Approved Section 4.55 (2) Modification Application

No: SSD 6966 MOD 1 Granted on 19 August 2021

ONE SYDNEY HARBOUR

BARANGAROO

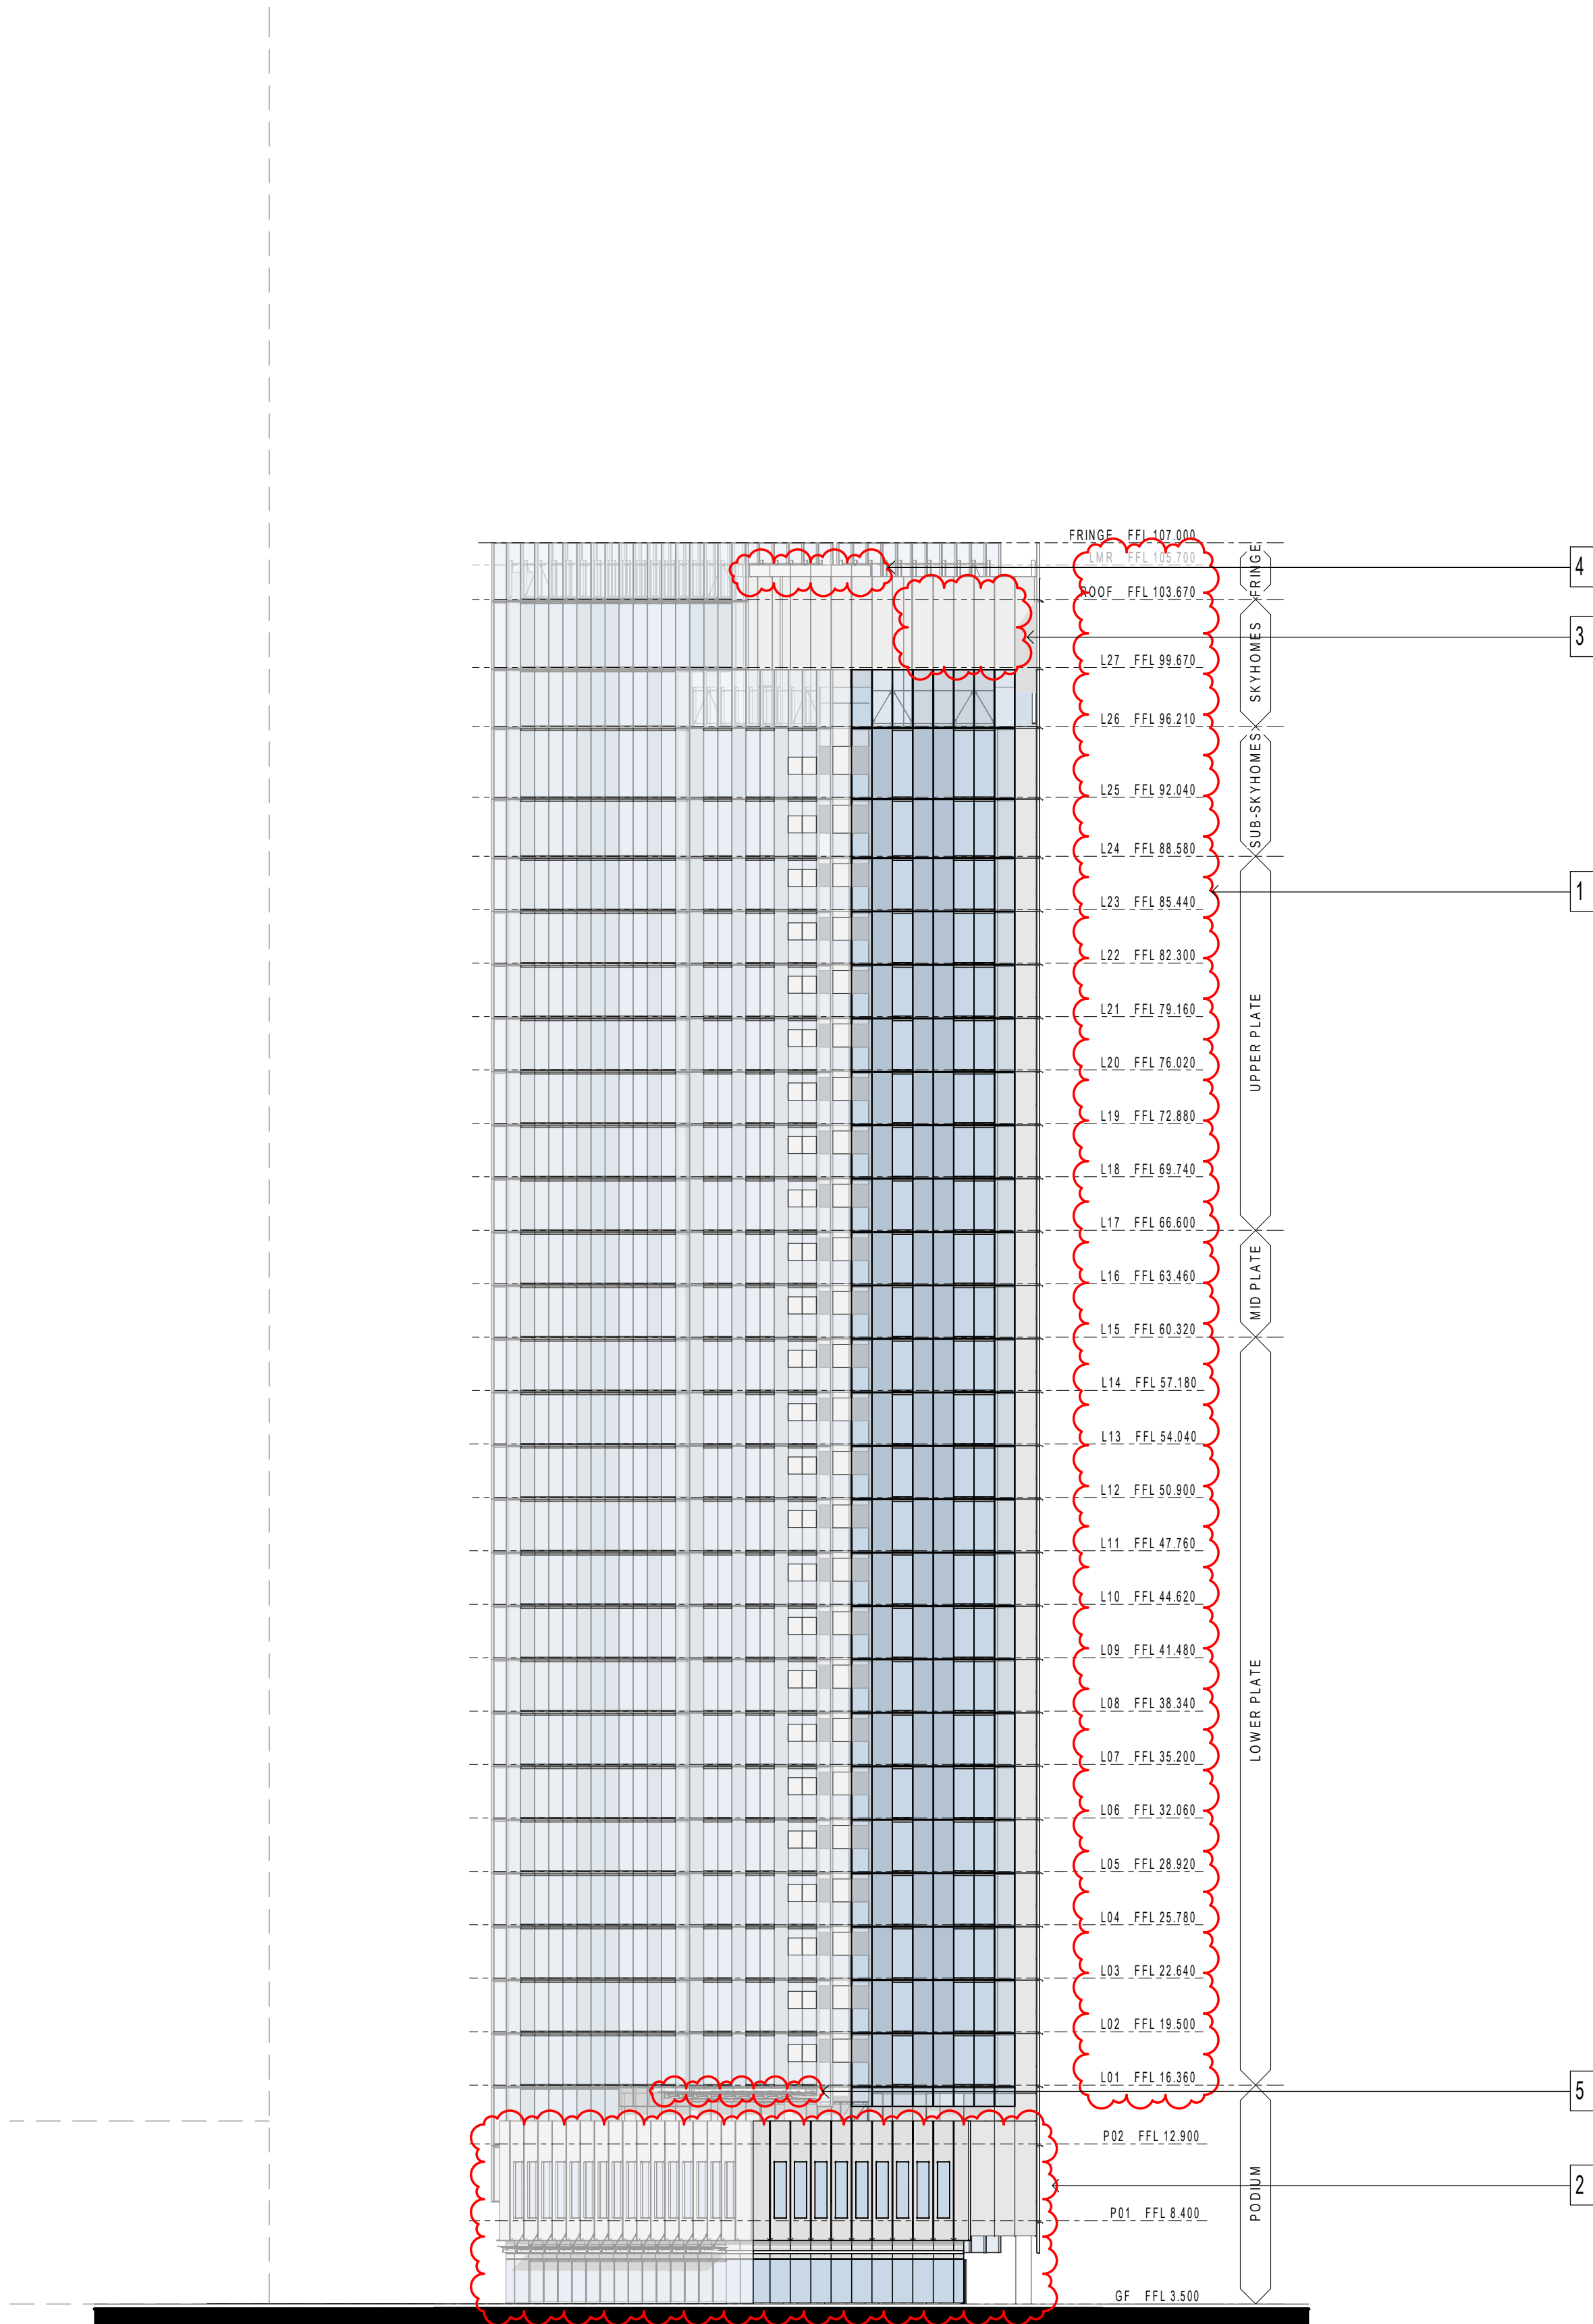
1. UPDATED LEVEL'S FFL
2. REMOVED EXTERNAL SHADING DEVICES
3. UPDATED PODIUM FACADE
4. LOWERED LMR HEIGHT
5. ADDED LOUVRED PANELS
6. SHIFTED CLADDING LINE
7. UPDATED BALCONIES TO FULL HEIGHT GLAZING FACADES
8. RETAIL DOORS ADDED

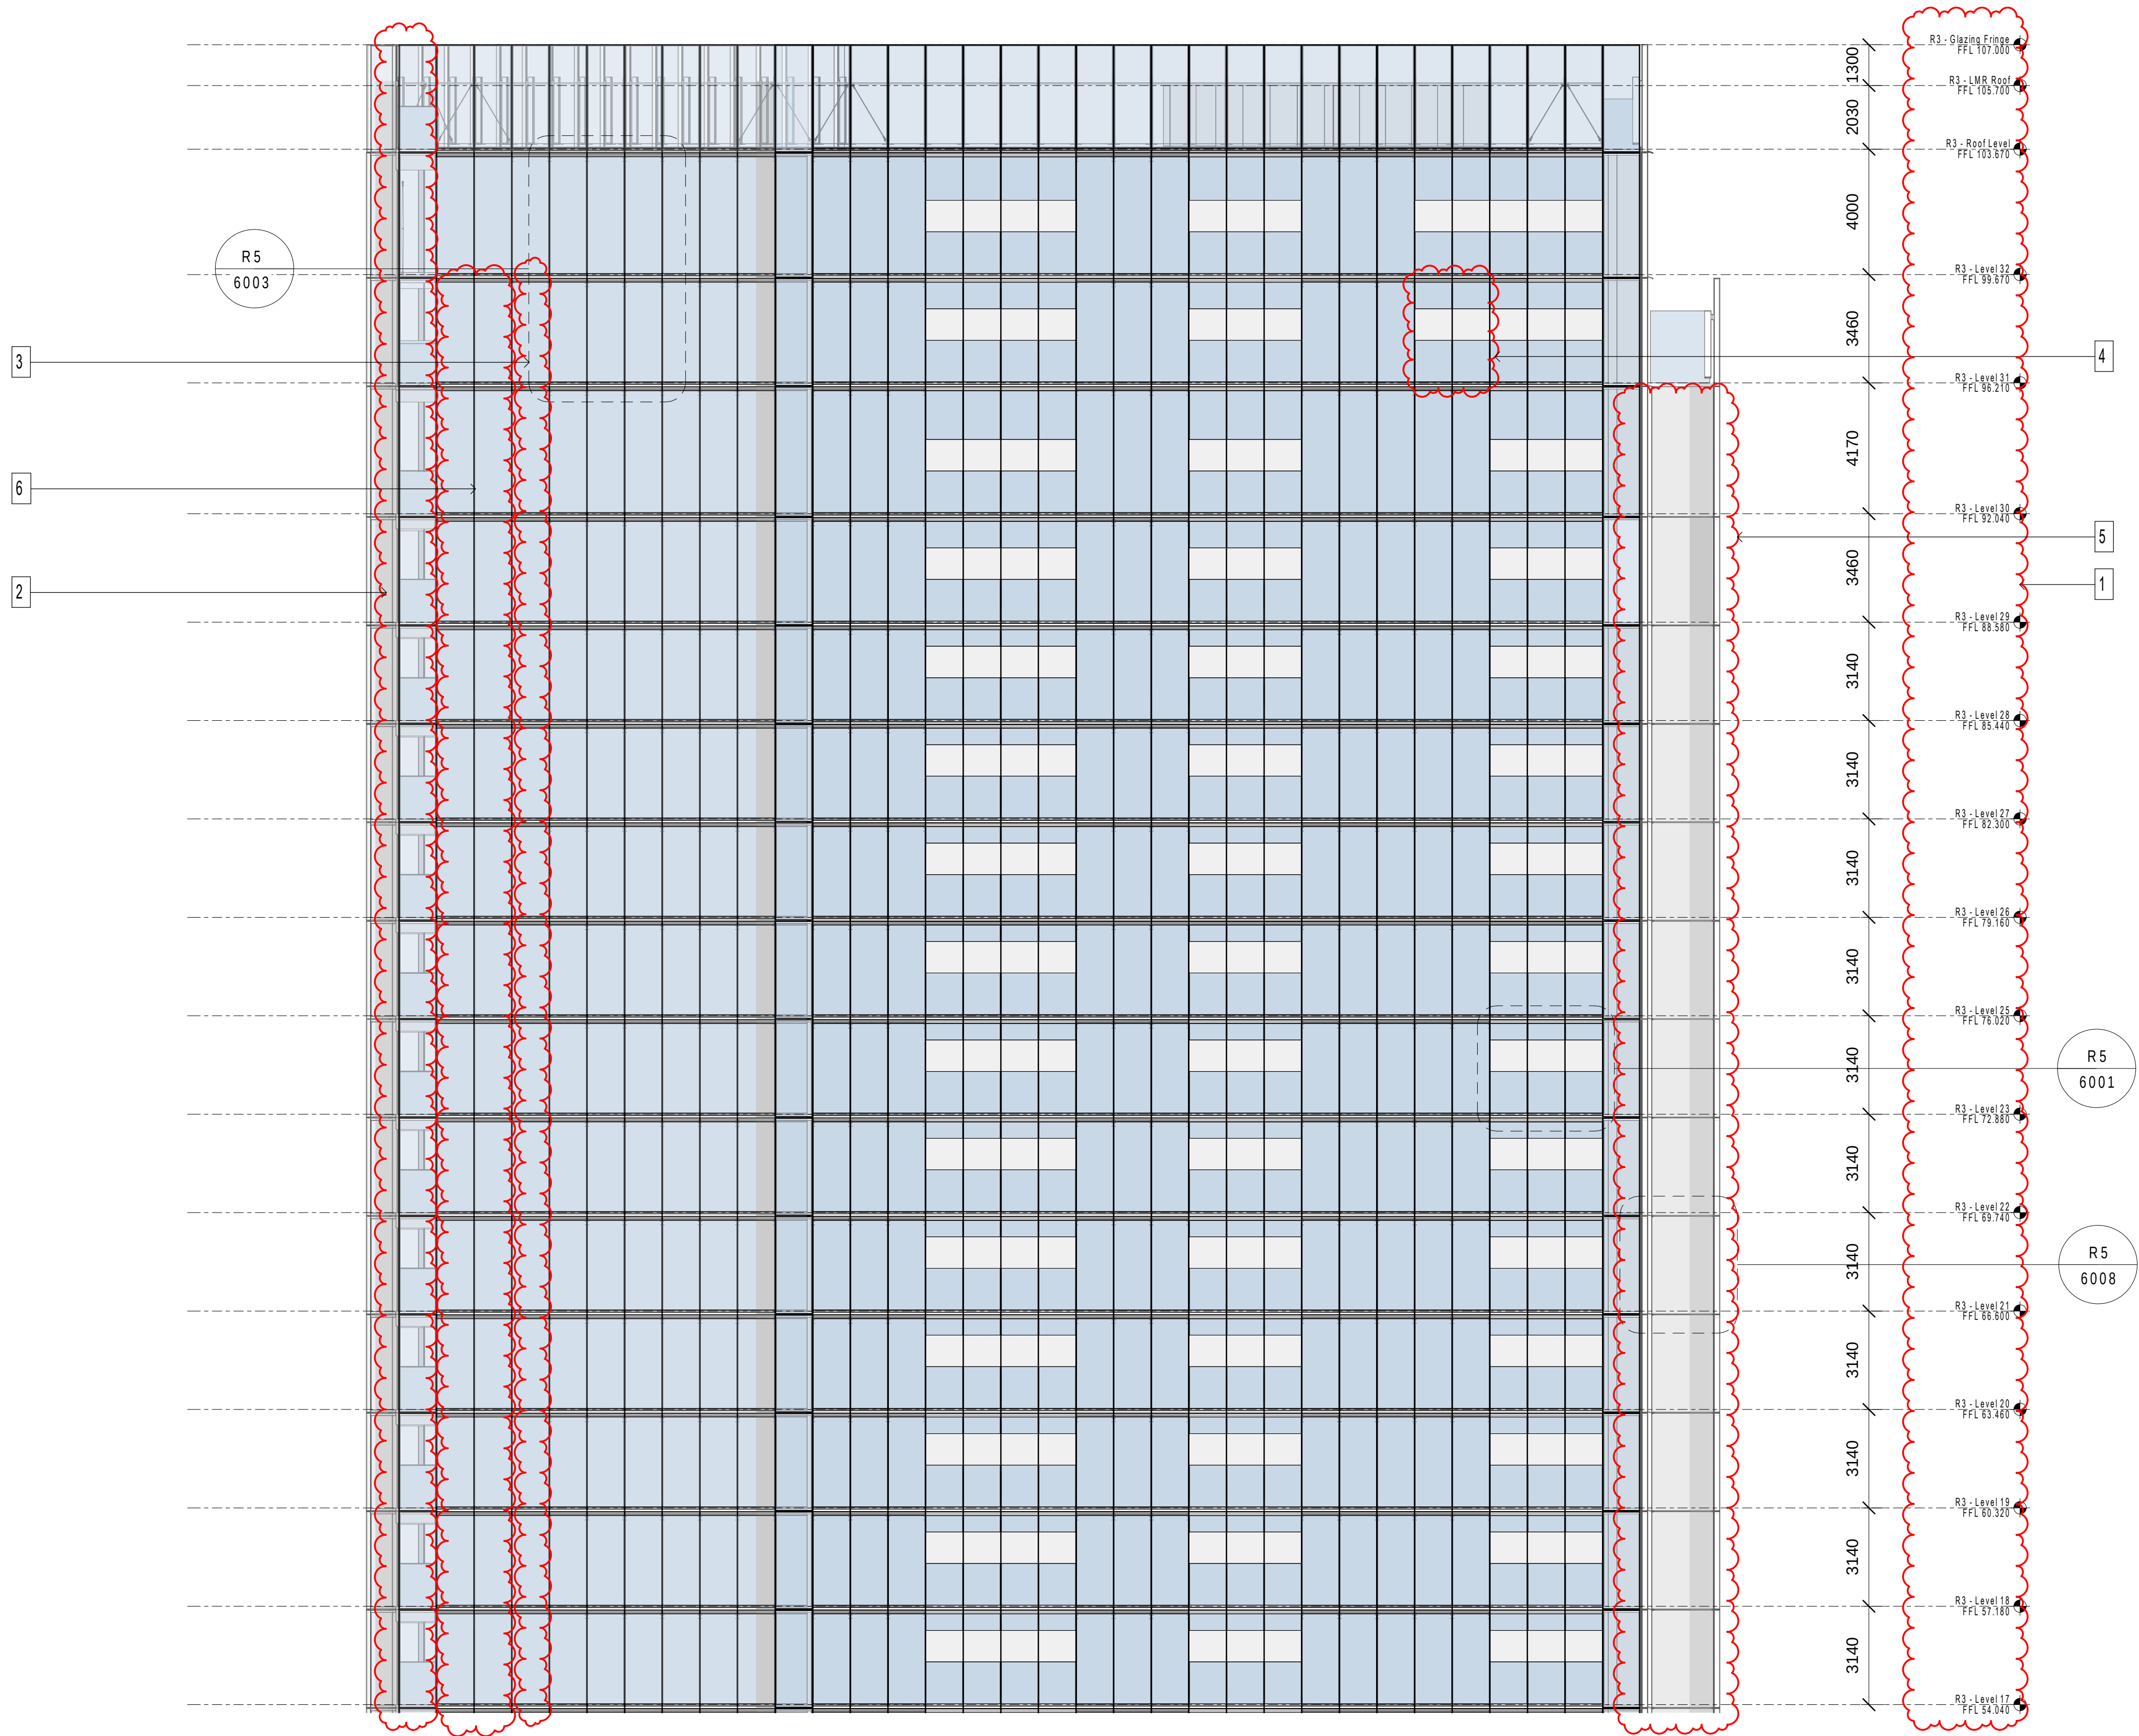
- MODIFICATION:**
1. UPDATED LEVEL'S FFL
 2. UPDATED PODIUM FACADE
 3. UPDATED AWNING DETAILS
 4. ADDED AWNING
 5. ADDED 1 FACADE MODULE
 6. UPDATED BALCONY TO OCF FACADE
 7. SHOWN INDICATIVE RETAIL DOOR LOCATION
 8. REMOVED NOTCH LIPS
 9. STRUCTURAL TIE BRACING ADDED
 10. UPDATED BALCONIES TO FULL HEIGHT GLAZING FACADES

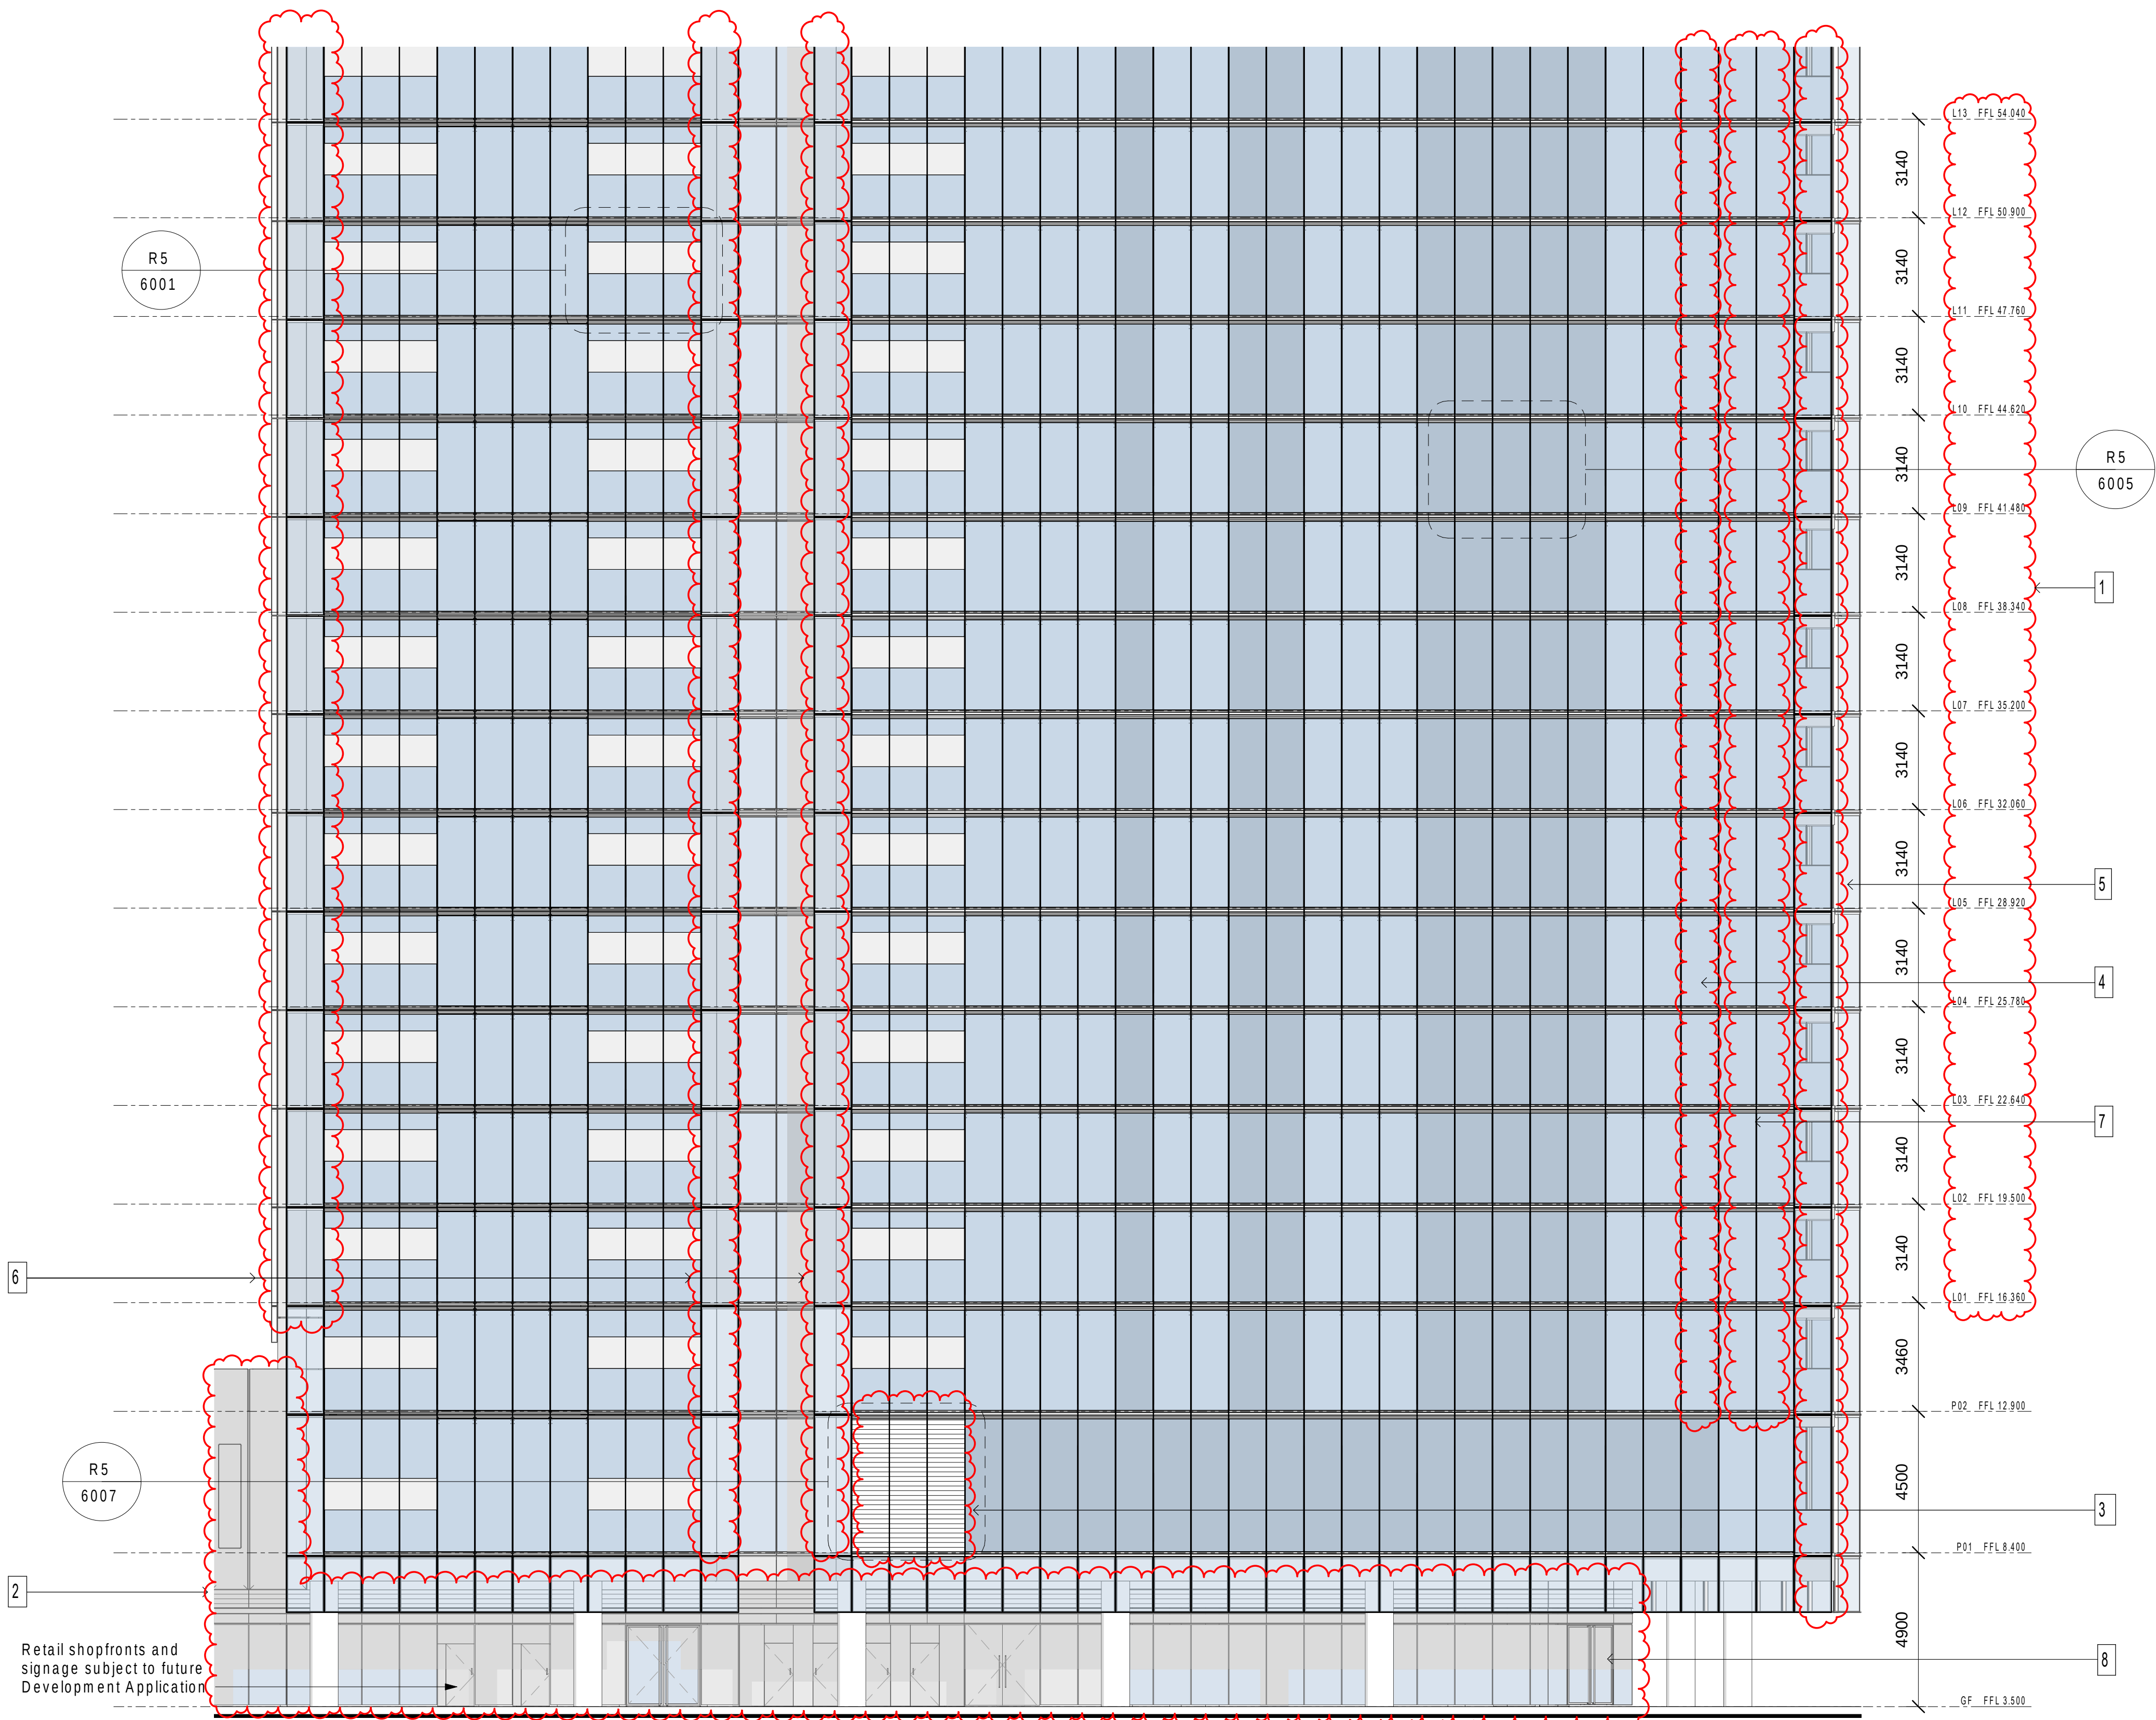
- MODIFICATION:
1. UPDATED LEVEL'S FFL
 2. UPDATED PODIUM FACADE
 3. ADDED LOUVRED PANELS
 4. UPDATED BALCONY TO OCF FACADE
 5. ADDED 2 FACADE MODULES
 6. REMOVED NOTCH LIPS
 7. UPDATED BALCONIES TO FULL HEIGHT GLAZING FACADES
 8. RETAIL DOORS ADDED
